RE: Phase II Athletics - Change Order 11 - All High Schools - Electrical and Plumbing Revisions **DC**

AIA® Document G701® – 2017

PROJECT: *(Name and address)*
BCPS - Phase II Athletics - Bid Package
No. 1 - Baseball and Softball
Bullitt County, Kentucky

CHANGE ORDER INFORMATION:
Change Order Number: 011
Date: December 16, 2024

E3.4
BEHS

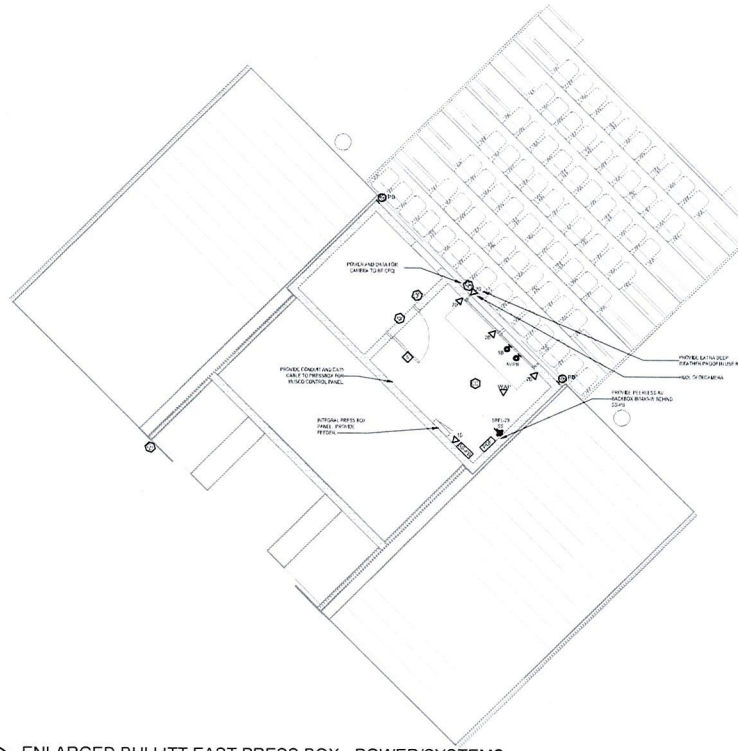
- Item No.1** Refer to ES1.3, ES2.2, ES2.3, ES3.3 and ES3.4:
- Indicated straight line home run to serving panelboard for scoreboard panel. Clarification from Addendum.
- Item No.2** Refer to E3.4 BEHS:
- Added circuiting to tie into existing circuit for exhaust fan
- Item No.3** Refer to E5.5: **Sheet Revised 10-24-2024**
- Clarified baseball/softball scoreboard panelboard feeders.
- Item No.4** Refer to E5.6: **Sheet Revised 10-24-2024**
- Clarified baseball scoreboard panelboard feeder. Clarified baseball branch circuits from shop drawing review.
